PROJECT REVIEW

1. CASE 24.065, 57 SHELDON STREET, John Justin House, 1828 (COLLEGE HILL)

Greek Revival; 2-1/2 stories; clapboard; gable roof; 5-bay façade with central doorway in classical enframement.
CONTRIBUTING

Rev. No. R1 Sheet PV-2

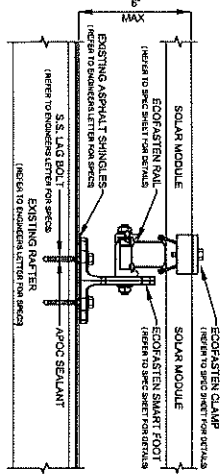
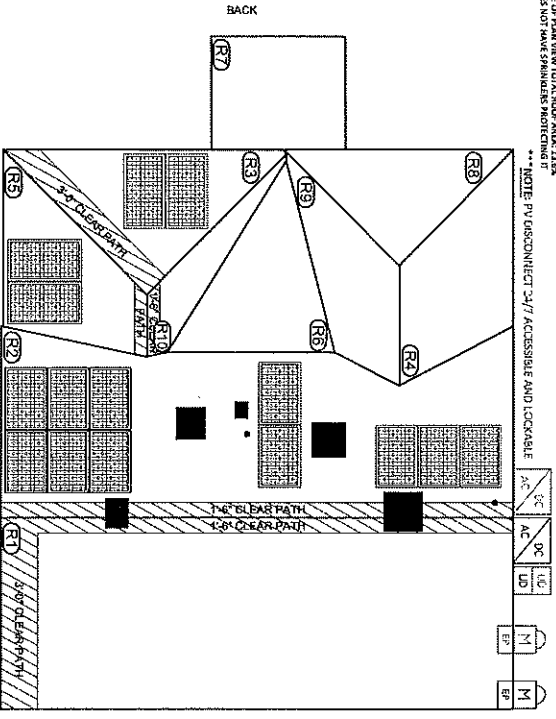
- installation of 11 solar panels to the south slope of the side gable, and four panels at the southeast gabled corner of the roof;

- The application as submitted will not be visible from the public rights-of-way;
- The modifications as proposed meets Minor Alterations: Solar Energy Systems Guidelines, Section 2, in the following manner: Panel layout shall be sympathetic or appropriate to design and scale of building. Rectangular configurations are preferred, with ample setback from edge of roof, dormers, chimneys, etc. (2.A); Panels shall be installed parallel to the existing roof slope and matched as closely as possible to the roof plane (2.B); Panels shall be installed without destroying or replacing original or historic materials or significantly compromising or altering the building's structural integrity (2.C); Panels shall be compatible in color to existing roofing insofar as possible (2.D); Installation of panels shall be as inconspicuous as possible when viewed from public right-of-way (2.E); Installation shall be reversible. Panels shall be removed when no longer viable or functioning and roofing restored to pre-existing conditions (2.F); and,

- b) The modifications as proposed meets Minor Alterations: Solar Energy Systems Guidelines, Section 2, and the application is considered complete; and,

- c) The work as proposed is in accord with PHDC Standards 8 & 9 as follows: 8) the work will be done so that it does not destroy the historic character of the property or the district as they are not on the primary elevation and will not be visible from the public rights-of-way; and, 9) Whenever possible... alterations to structures shall be done in such a manner that if removed in the future, the essential form and integrity of the structure and the site will be unimpaired.
